ACCESS REPORT

UTS CENTRAL

Revised SSD 7382 SUBMISSION

28th April 2016

External Pathways and Building Entrances (Parts D3.2 & D3.3 of the BCA)

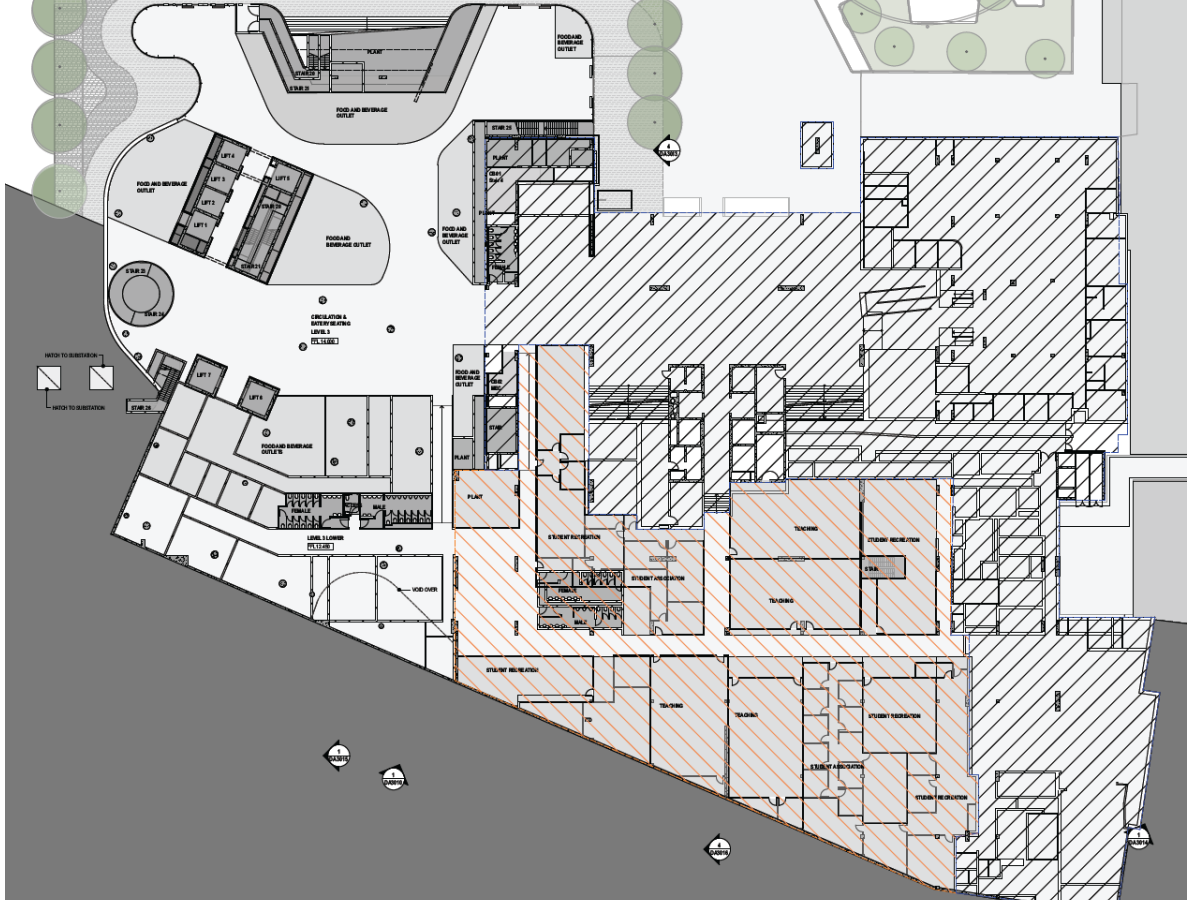
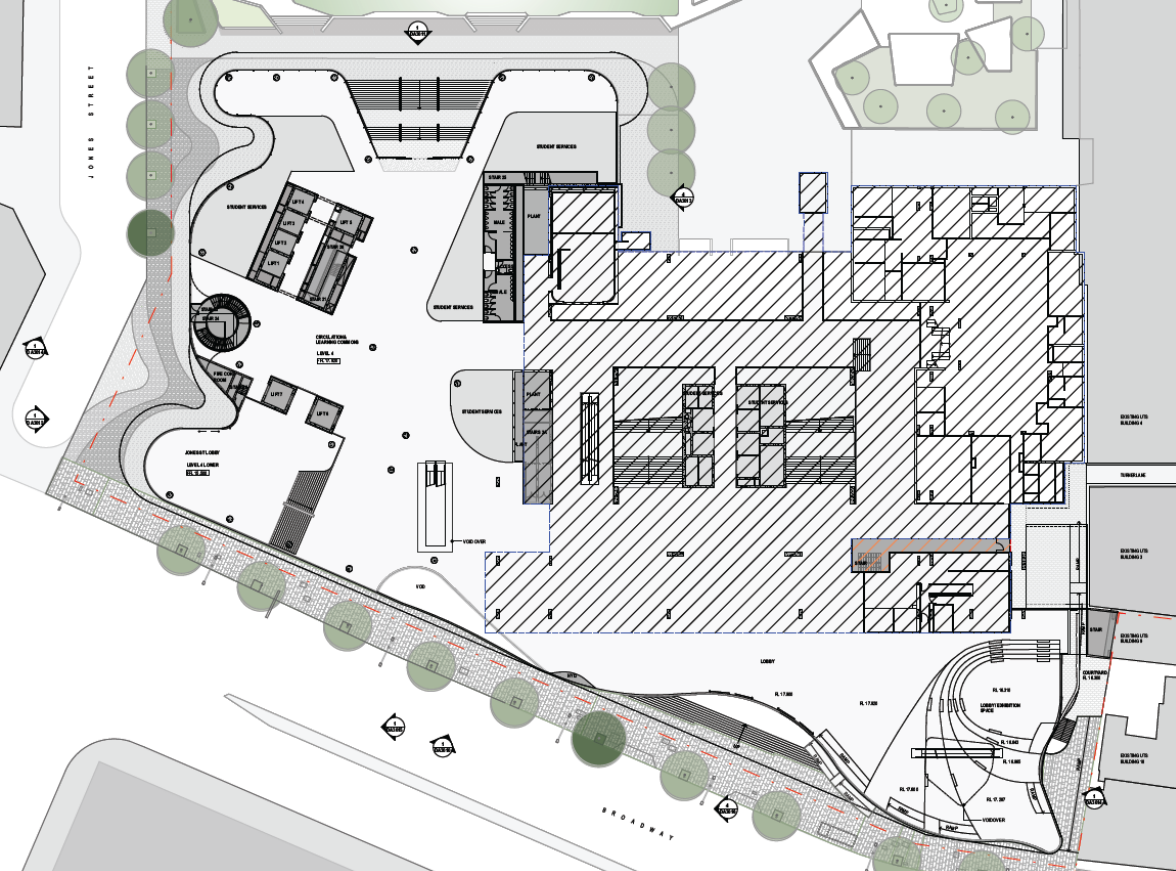
BCA / DDA Access Code Review	Complies
Ground plane entrances (Levels 3 and 4 on plan) Overview <ol style="list-style-type: none"> The development is located in an area that has a slope across the site that incorporates an accessible building entrance at the lower ground floor at level 3 on plan adjacent to the Alumni Green and accessible links to the ground floor entrances from the existing building CBI and Jones Street. Ground Floor Entrances – The new building works provide several entrances and entry points to access the combined buildings CBI and CB2. The new works propose three new or modified principal entries at the ground planes as follows; <ol style="list-style-type: none"> Broadway – The plans propose an extension at Level 4 that in-fills the forecourt adjoining Broadway and provides 1:14 ramp and stairway access to the principal building entrance @RL17.920. Jones Street – The development proposes an on-grade level entry from the western approach on Jones Street to a lower ground floor lobby @RL15.500 (lower Level 4 on plan) which incorporates lifts, escalators and stairs that interface with the split levels on Levels 3 and Level 4 @RL17.920 and provide direct access to Levels 5, 6, 7 and 8. Third entry from the Alumni Green internal courtyard on the northern side of the building will incorporate on-grade level access to Level 3 @RL14.000 and stairway access to Level 4 @RL17.920. 	<p>YES</p> <p>YES</p> <p>YES</p> <p>YES</p>

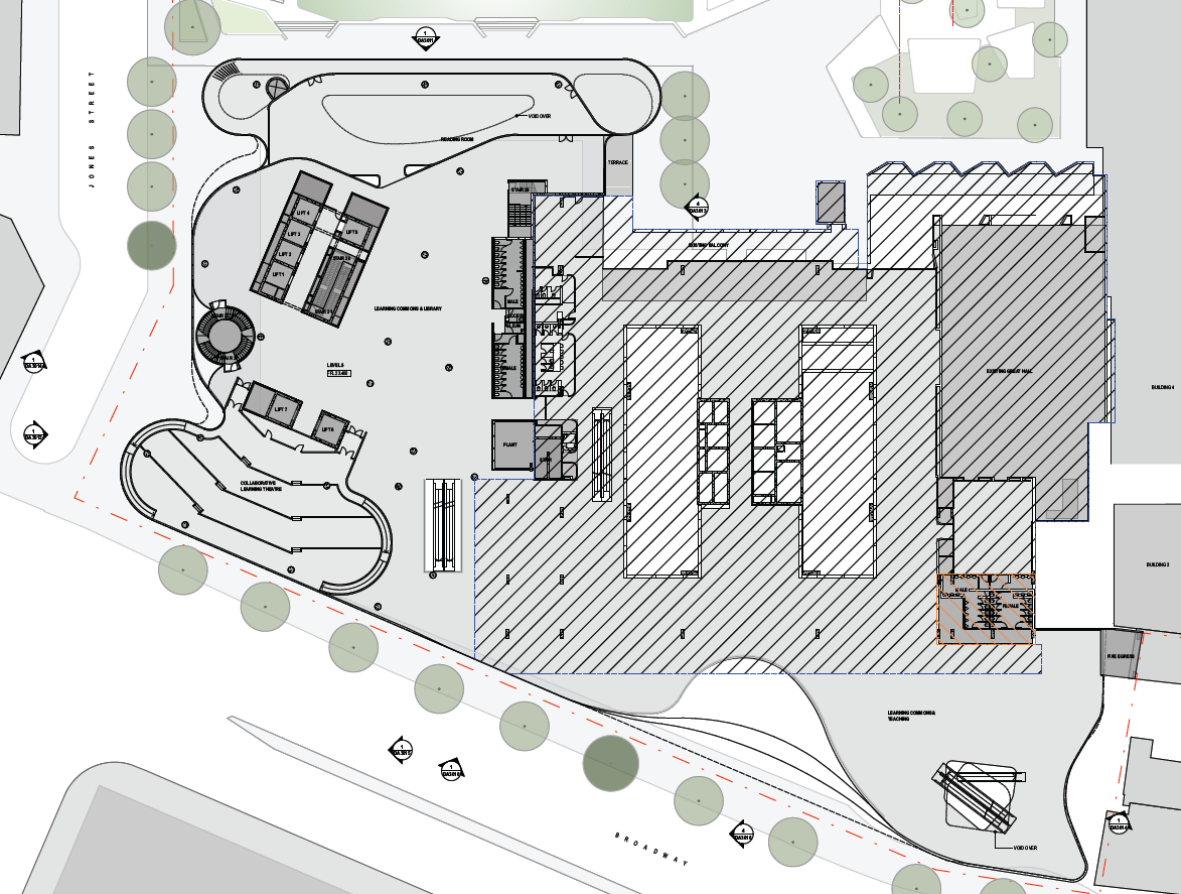
BCA / DDA Access Code Review	Complies
<p>3. Existing Alumni Green Courtyard Entrance to CBI - At the level 3 on plan the existing entry doorway with at-grade access from an adjoining courtyard accessways remains unchanged.</p>	No Change
<p>Lower Ground Floor Level 3</p> 	
<p>4. The new works to split levels of Buildings CBI and CB2 will vastly improve access for people with disabilities in a manner consistent with AS1428.1 to satisfy Parts D3.2 and D3.3 of the BCA and DDA Access Code.</p> <p>5. The entrance ramps and stairs will be detailed with handrails, tactile ground surface indicators and other features as required by AS1428.1 and AS1428.4.1 to satisfy Parts D3.3 and D3.8 of the BCA and DDA Access Code.</p> <p>6. The existing and new entrance doorways indicate auto sliding doors that provide circulation spaces that will comply with AS1428.1 and satisfy Part D3.2 of the BCA and DDA Access Code.</p> <p>7. Doors will be documented at a future stage to confirm 850mm clear opening widths, level threshold, doorway luminance contrast, glazing markings where required and doorway hardware complying with AS1428.1 to satisfy Part D3.2 of the BCA and DDA Access Code.</p> <p>8. Overall, the plans illustrate appropriate access to enter the building from all approaches at the ground floor levels consistent with AS1428.1 to satisfy Part D3.2 of the BCA and DDA Access Code.</p>	<p>YES</p> <p>YES at CC stage</p> <p>YES</p> <p>YES at CC stage</p> <p>YES</p>

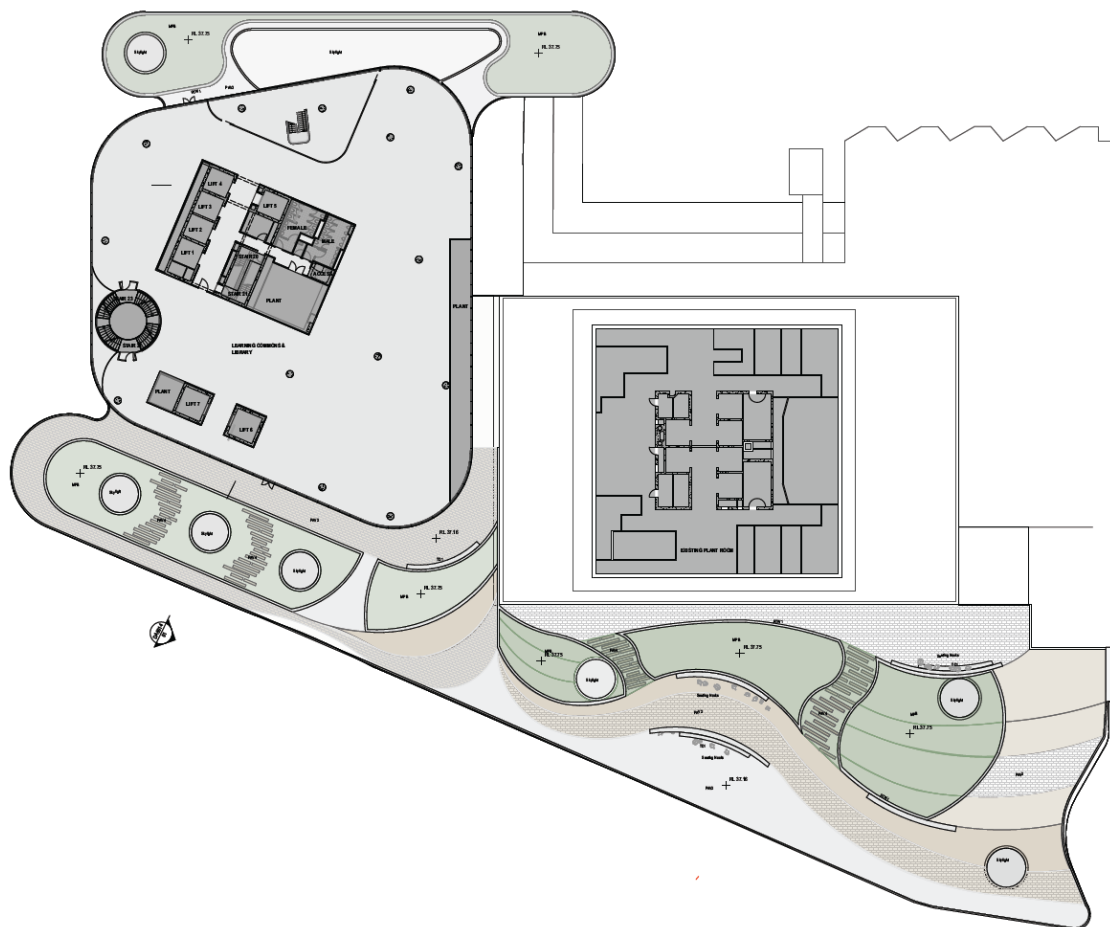
BCA / DDA Access Code Review	Complies
<p>Level 4 (Ground Floor)</p> 	
<p>17. At level 4 the open plan foyer areas of CB1 and CB2 provide ample circulation spaces to access all areas on the ground floor that facilitate Turning and Passing areas in accordance with ASI428.1 to satisfy Part D3.3 of the BCA and DDA Access Code.</p> <p>18. The new foyer extension to Building CB1 shall incorporate an amphitheatre that will have a ramp to all levels to ensure equitable access for all that will comply with D3.3 of the BCA and DDA Premises Standards. Future detailed design of the ramps and stairs on the ground floor shall ensure compliance with ASI428.1 and ASI428.4.1 to fully satisfy Parts D3.3 and D3.8 of the BCA and DA Access Code.</p> <p>19. The new sanitary facilities can provide appropriate access in accordance with ASI428.1 to satisfy Parts D3.3 and F2.4 of the BCA and DDA Access Code, which will be confirmed at a future construction documentation stage.</p> <p>20. New Lifts 6 and 7 enable access from the Jones Street entrance to the main Level 4 floor area and levels 2 to 9 while Lifts 1 to 5 propose access to all levels 1 to 17 which will comply with D3.3 of the BCA and DDA Premises Standards. The new escalators provide access between levels 4, 5, 6 and 7.</p> <p>21. Overall, the plans illustrate appropriate access to circulate within the ground floor areas on level 4 consistent with ASI428.1 to satisfy Part D3.2 of the BCA and DDA Access Code.</p>	<p>YES</p> <p>YES</p> <p>YES Can Comply</p> <p>YES Can Comply</p> <p>YES</p> <p>YES</p>

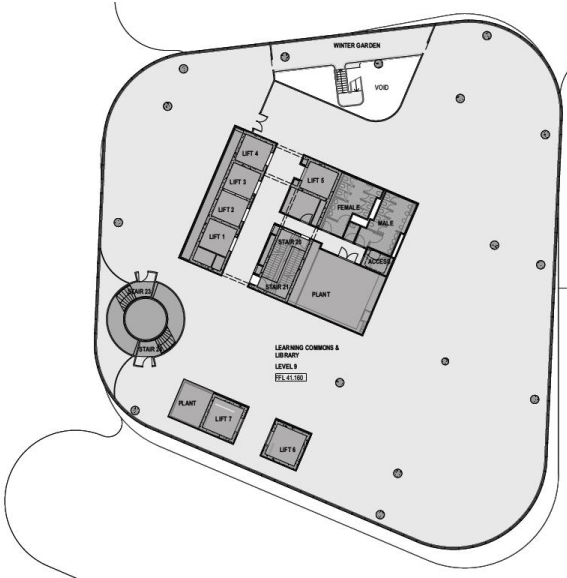
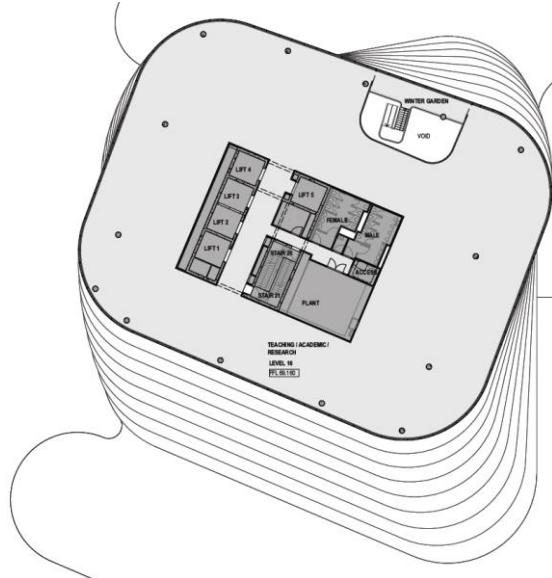
Level 5	Level 4	Levels 5 to 9	
<p>27. Detailing of the stairways and void balustrades shall require handrail extensions and tactile indicators to avoid conflicts with transverse accessway movement consistent with ASI428.1 to satisfy Part D3.3 of the BCA and DDA Access Code.</p>			YES Can Comply
<p>Level 7</p> 			
<p>28. At level 7 the new extension of Buildings CB1 and CB2 provide a single level @RL33.160. The plans indicate various uses of Library/Reading Room, Learning Commons and Collaborative Learning Theatres areas that can facilitate ample circulation spaces to access all areas in accordance with ASI428.1 to satisfy Part D3.3 of the BCA and DDA Access Code.</p>			YES

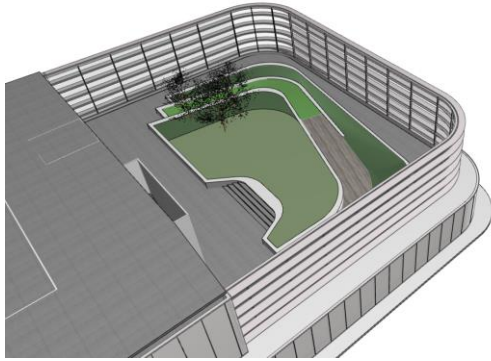
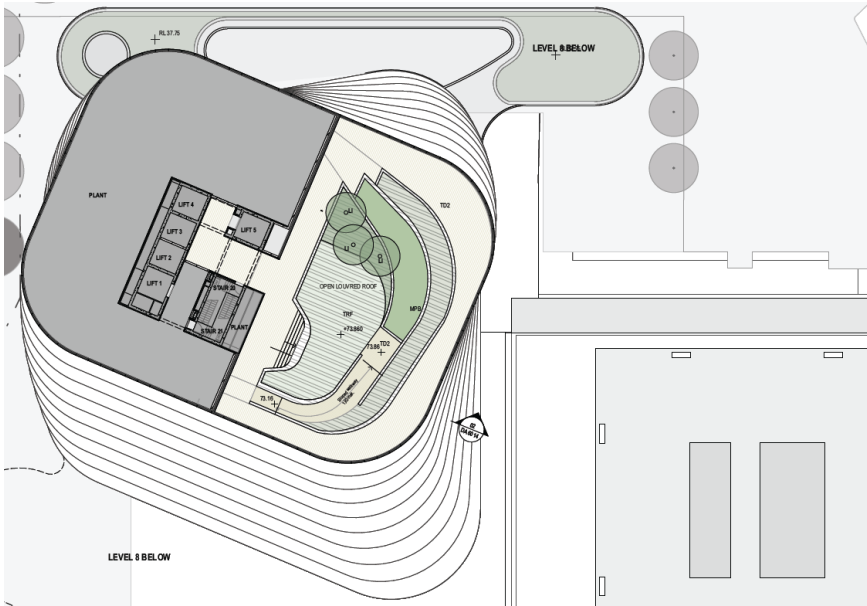
BCA / DDA Access Code Review	Complies
<p>29. Collaborative Learning Theatres – The plans indicate three (3) tiered platforms that will incorporate wheelchair access to at least two (2) levels to enable equitable and inclusive access.</p> <p>30. Detailing of ramps, stairs and fitout areas shall be confirmed at a future design stage in accordance with ASI428.1 to satisfy Part D3.3 of the BCA and DDA Access Code.</p> <p>31. The new sanitary facilities can provide appropriate access in accordance with ASI428.1 to satisfy Parts D3.3 and F2.4 of the BCA and DDA Access Code, which will be confirmed at a future construction documentation stage.</p>	<p>YES</p> <p>YES Can Comply</p> <p>YES Can Comply</p>

Accessible Sanitary Facilities

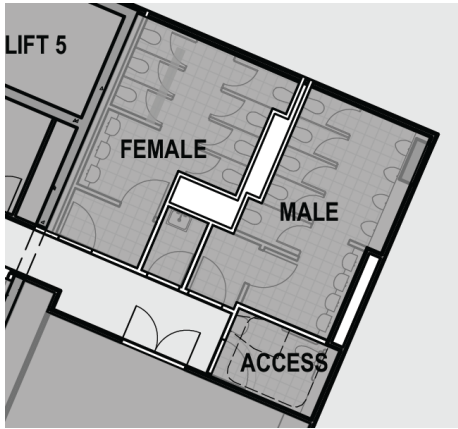
BCA / DDA Access Code Review	Complies
<p>53. Every Floor from Level 1 to 16 (except L2) has new sanitary facilities and will provide a unisex wheelchair accessible toilet on every floor and ambulant accessible male and female cubicles shall be included on each level to satisfy Part F2.4 of the BCA and DDA Access Code.</p>	<p>YES Can Comply</p>
